Product Recall

To: ALL DEALERS  
From: TRACY SAUERBREY - CUSTOMER SUPPORT DIVISION  
Subject: RECALL 05V-207 – 05-141 (Canadian) Webasto Coolant Heater  
Date: January 13, 2006

Recall 05V-207

Webasto's Process Instruction for the replacement of Burner Tube

Figure 5

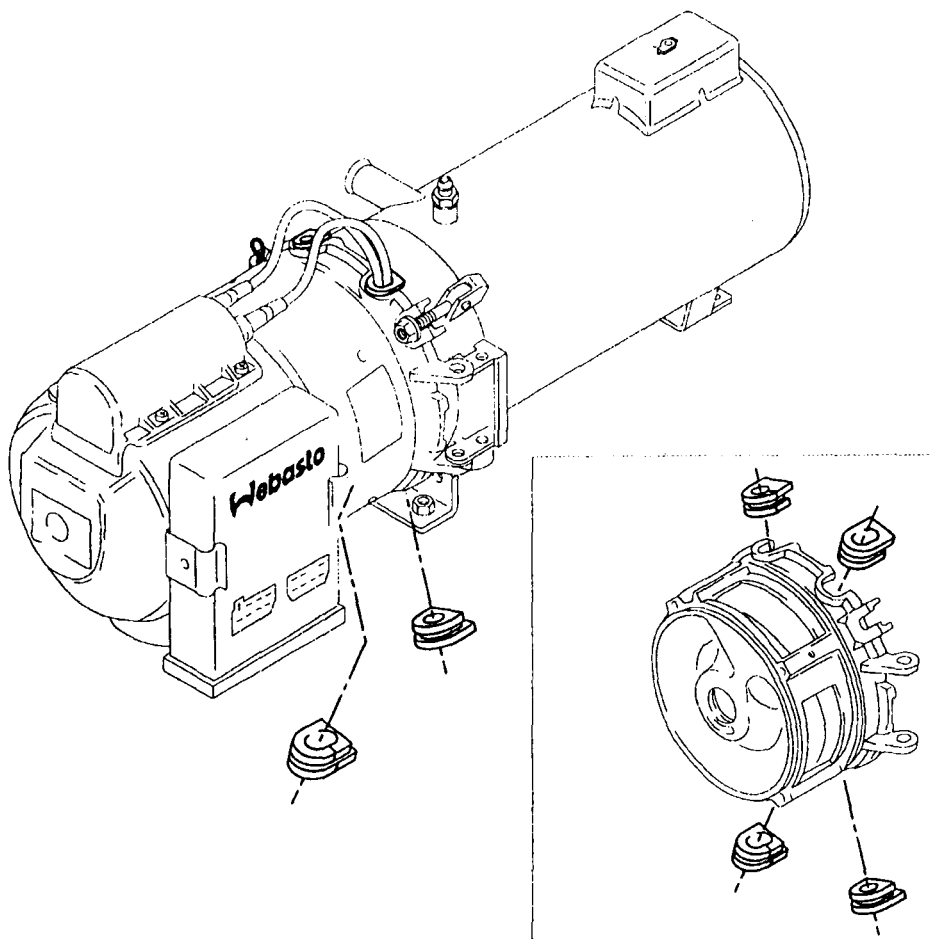
Once the burner head has been re-installed, make sure that all four grommets (2 right and 2 left) are in place. To minimize combustion air leakage, ensure grommets are fitted tightly around wire cables and fuel pipes. (see fig. 5).

In the case of the Scholastic Series heater with a **single line fuel system**, make sure the blank fuel pipe slot in the casting has a **solid (no hole) grommet** in place.
